**GENOA CHARTER TOWNSHIP
Application for Re-Zoning**

**GENOA CHARTER TOWNSHIP
PLANNING COMMISSION
PUBLIC HEARING
October 15, 2024**

OPEN PUBLIC HEARING #1... Consideration for a rezoning application, PUD agreement, Environmental impact assessment, PUD conceptual and preliminary site condo plan to rezone 127.57 acres from Agriculture (AG) to Low-Density Residential (LDR) with a RPUD overlay to allow for a proposed 58-unit single-family site condominium development located at the northwest corner of Challis Road and Bauer Road. The proposed rezoning is for the following parcels: 4711-23-400-008, 4711-23-400-007, 4711-23-400-001 and 4711-23-300-003. The request is submitted by Pulte Homes of Michigan.

On behalf of Pulte Homes of Michigan LLC (Applicant) and Asa Genoa, LLC, Eisenberg Brighton Genoa, LLC and Are five Family Limited Partnership (Owners), we are pleased to submit a Conceptual Site Plan for **Legacy Hills**, a **58 unit**, single family residential site condominium for your consideration.

PARALLEL SITE PLAN

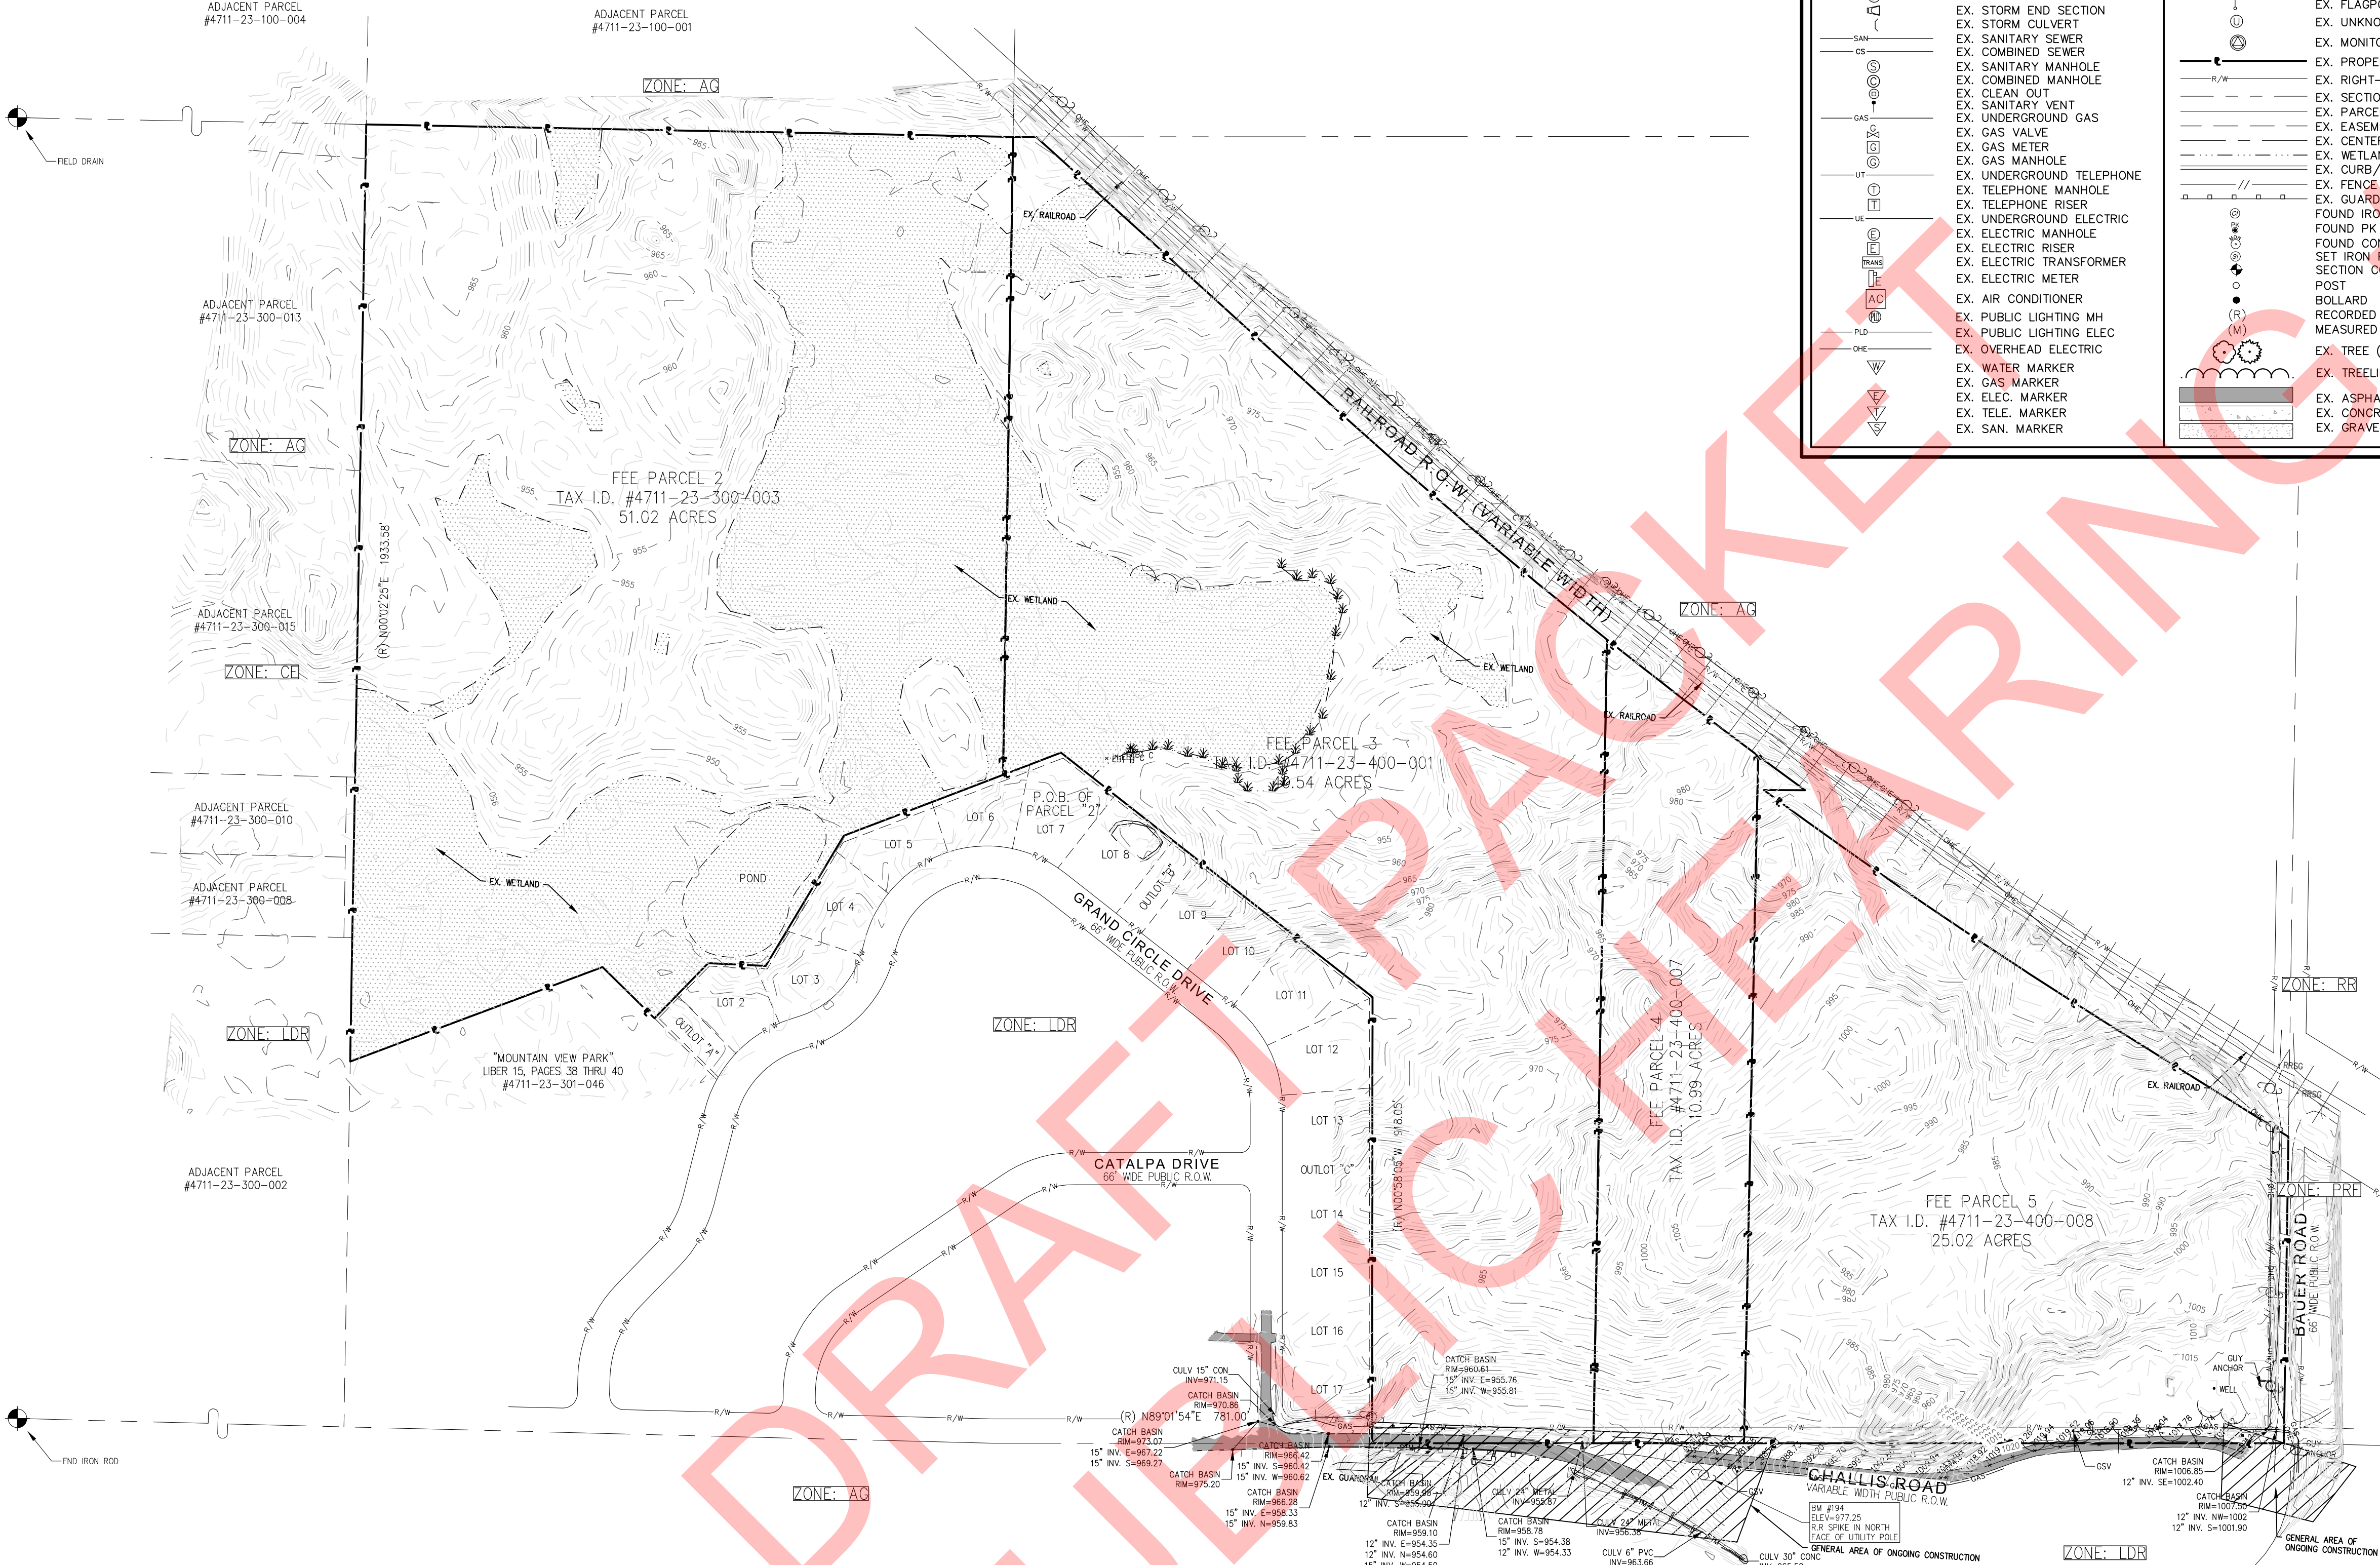
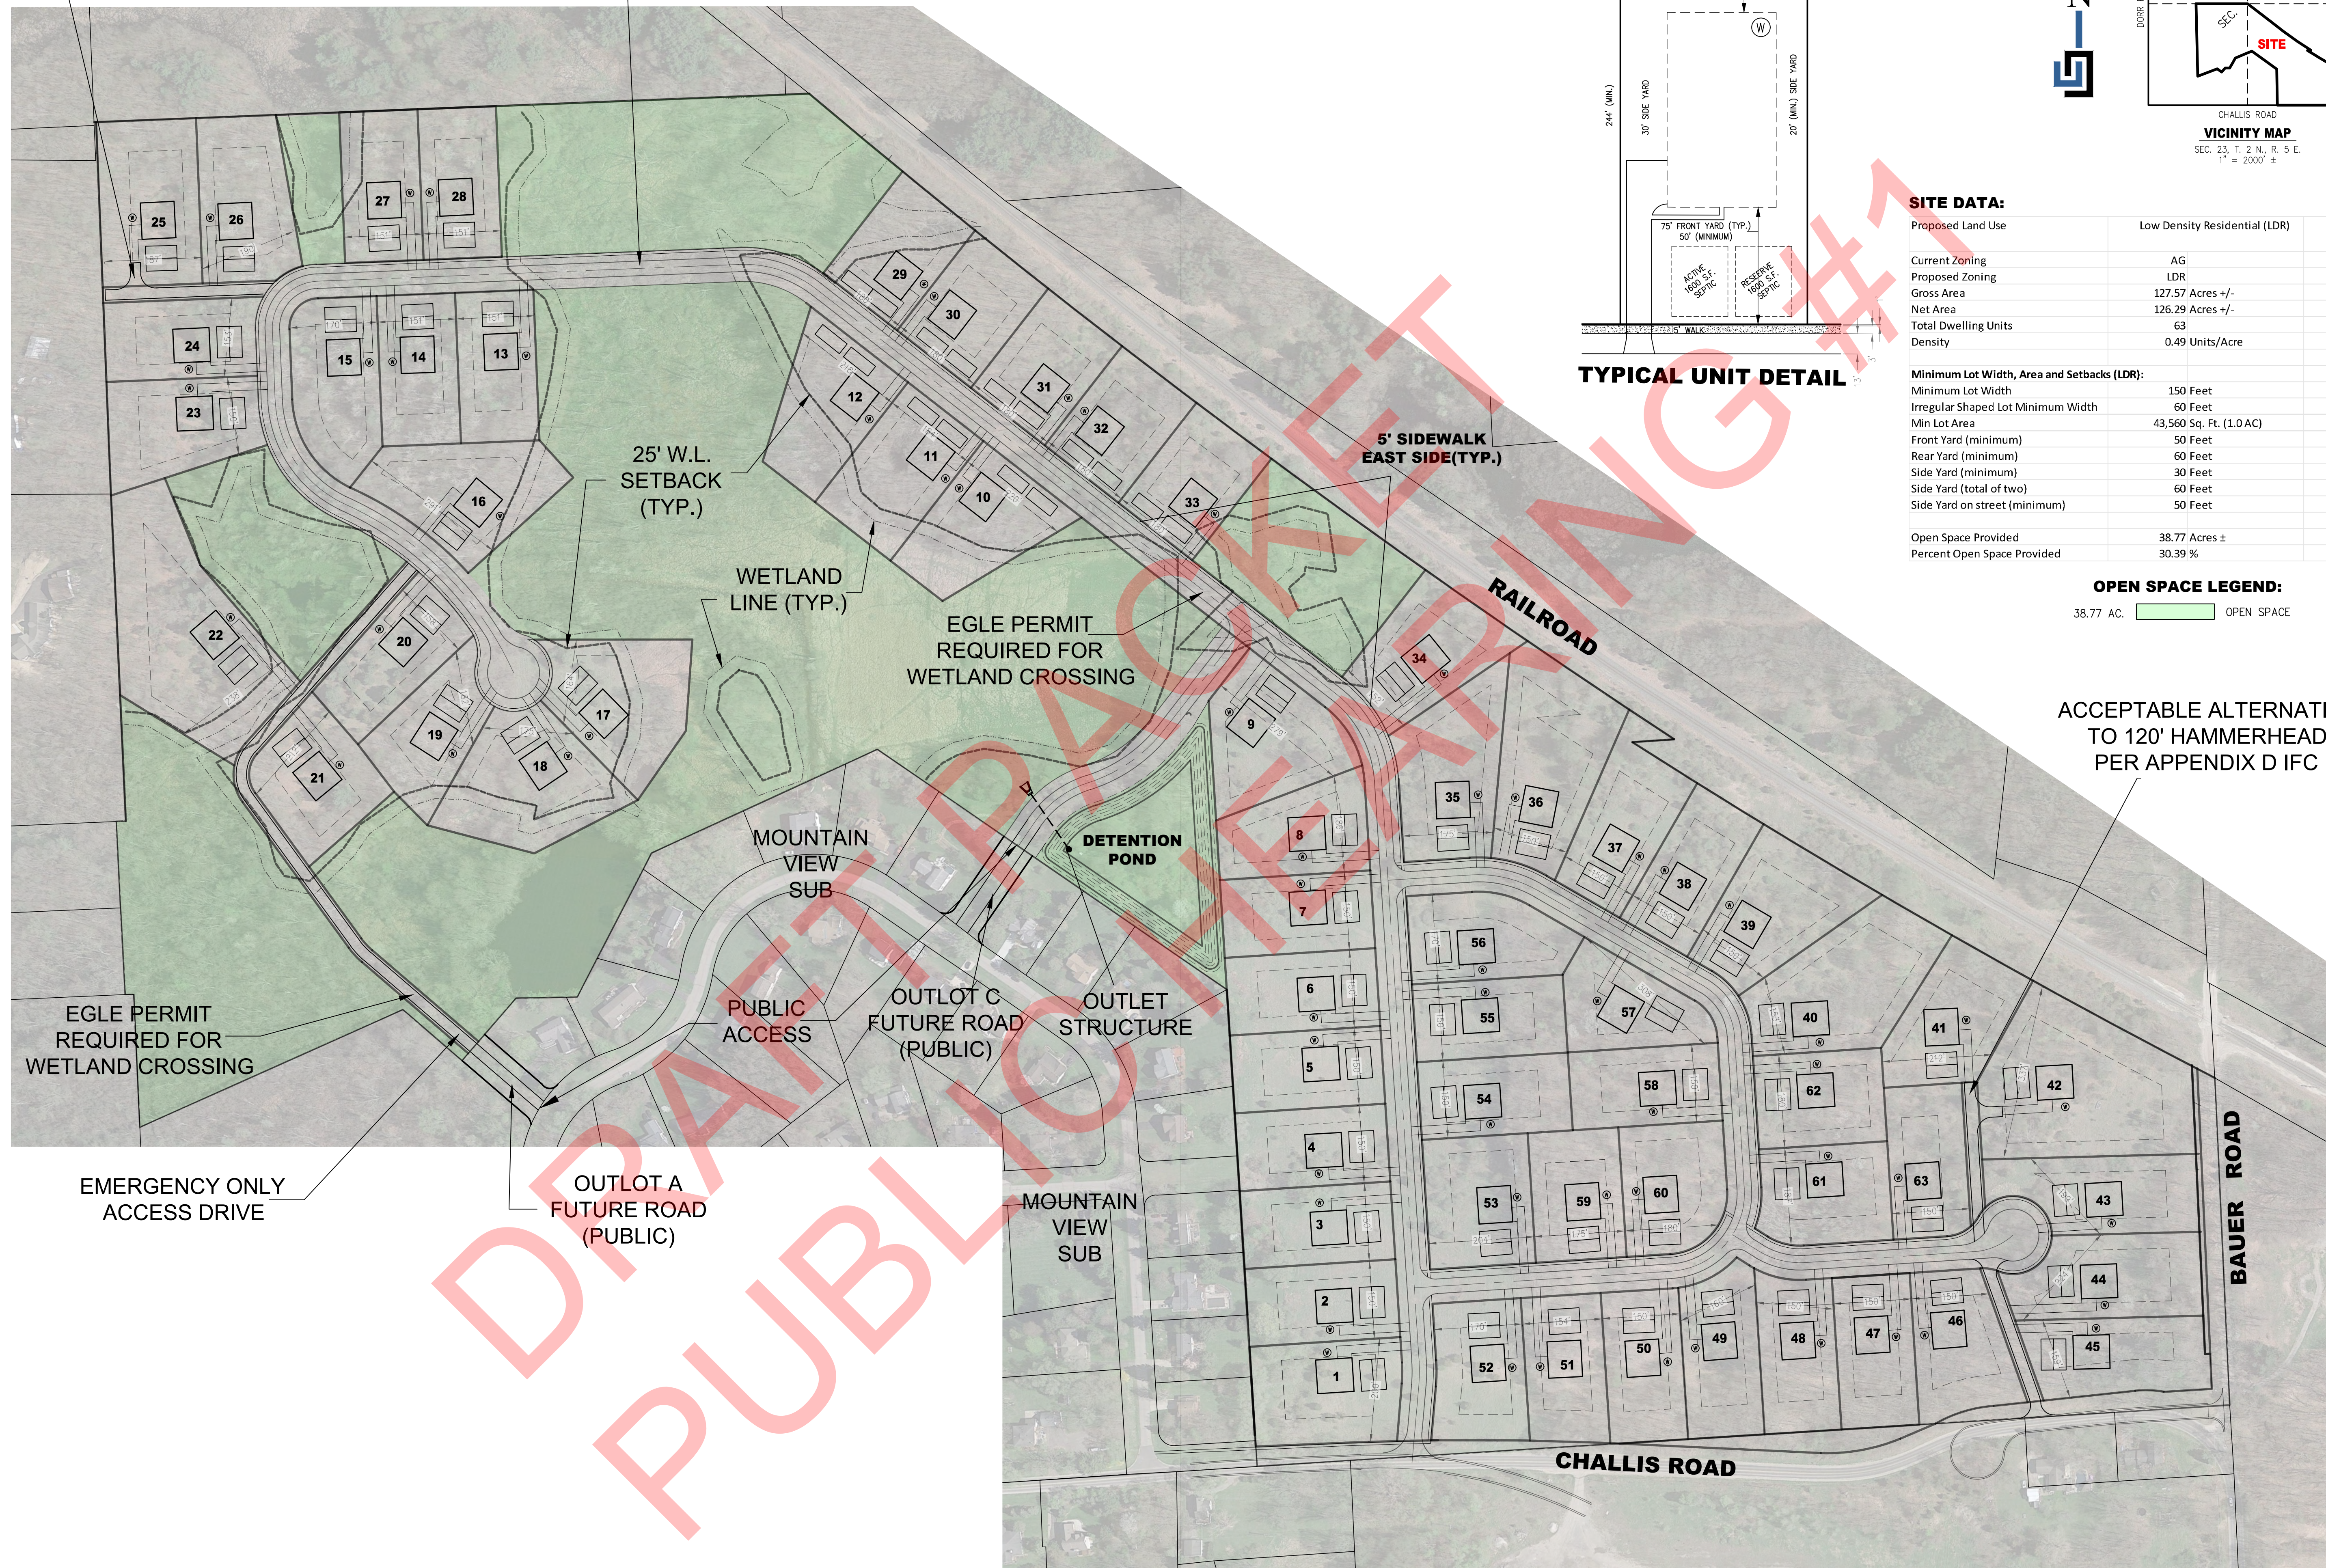
Commissioner Rauch thanked the applicant for meeting with the neighbors. He is concerned that the plan has as minimum of three lots that should not be considered, specifically Lot #'s 10, 11 and 12. Also, there are 13 additional lots that should not be included due to the wetland crossing that leads to them. He is not confident that EGLE would approve that road to cross the wetland. He would also like to see the preservation of the natural features that abut the adjacent properties. Additional details should be provided for the detention basin. He would like to see the completed traffic study, which will include the new roundabout. He is not in favor of moving this forward this evening.

Mr. Rauch would like to see evidence that Lots #10, 11 and 12 are buildable lots, the distance of the cul-de-sac and some details of the retention basin and storm management plan.

Commissioner McCreary would like to see the traffic study. She questioned the wetland delineations shown on the plan and those that encroach onto some of the lots. Mr. Noles reviewed how those were determined and then the process they will follow with EGLE for them. She asked if they have determined if their wells will affect the neighboring residents' wells. Mr. Noles stated their proposal has met all of the requirements of The Livingston County Health Department for the wells.

1. We have revised the Parallel Plan to address the comments of the Planning Commission by showing a typical house, well, and septic to further illustrate feasibility. The number of Units on the Parallel Plan has been increased from 58 to 63. However, the Cluster Plan still proposes 58 Units.

2. We have added a sidewalk to the East side of the internal roads on both the Cluster and Parallel Plans.
3. Considered two pathway options as noted in comment below.

EMERGENCY VEHICLE PLAN

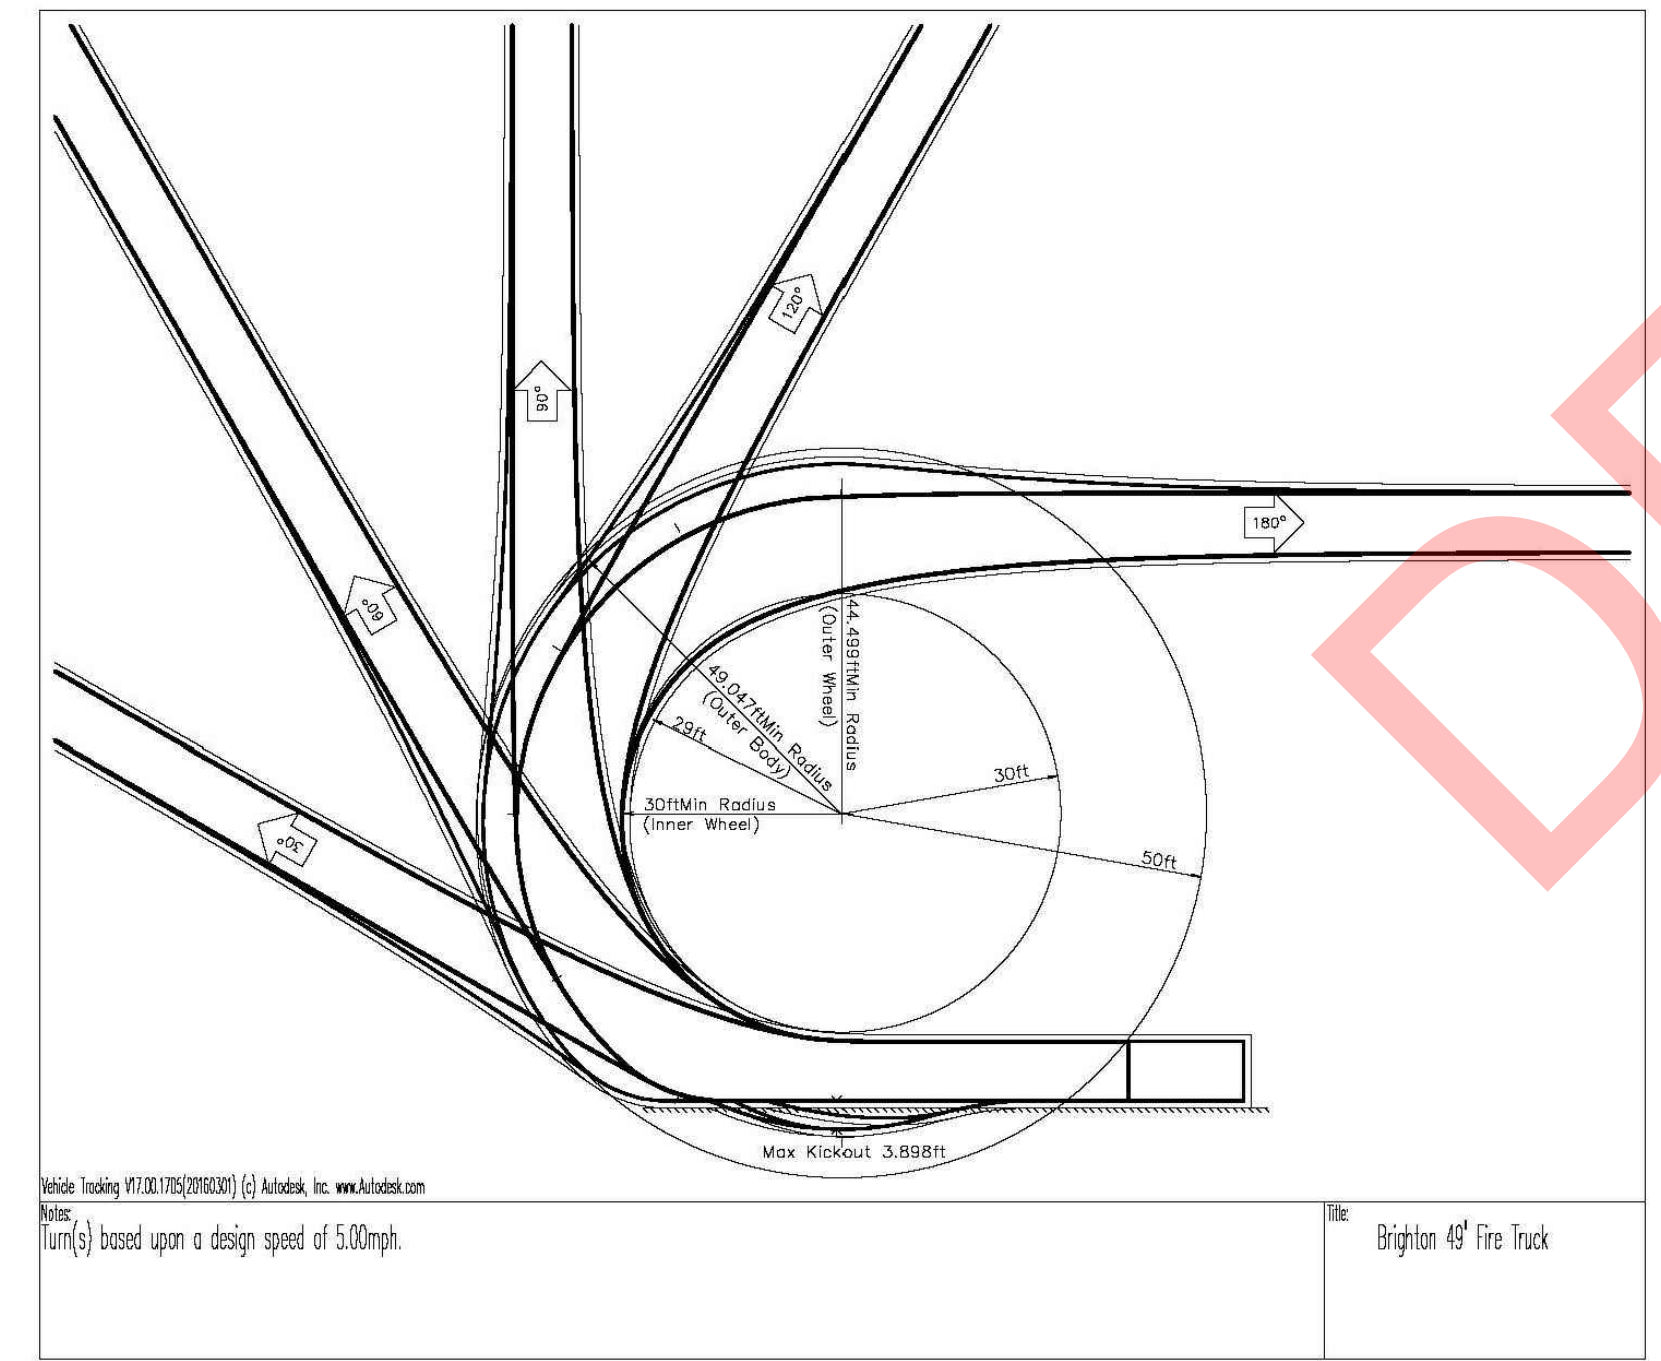
1. Fire protection water supply will be discussed further once the final site plan has been completed.
2. Access around the building shall provide emergency vehicles with a turning radius of 50 feet outside and 30 feet inside. Vehicle circulation shall account for non-emergency traffic and maintain the vehicle within the boundary of lanes of travel. Provide an emergency vehicle circulation plan. The cul-de sacs shall meet Appendix D of the International Fire Code.
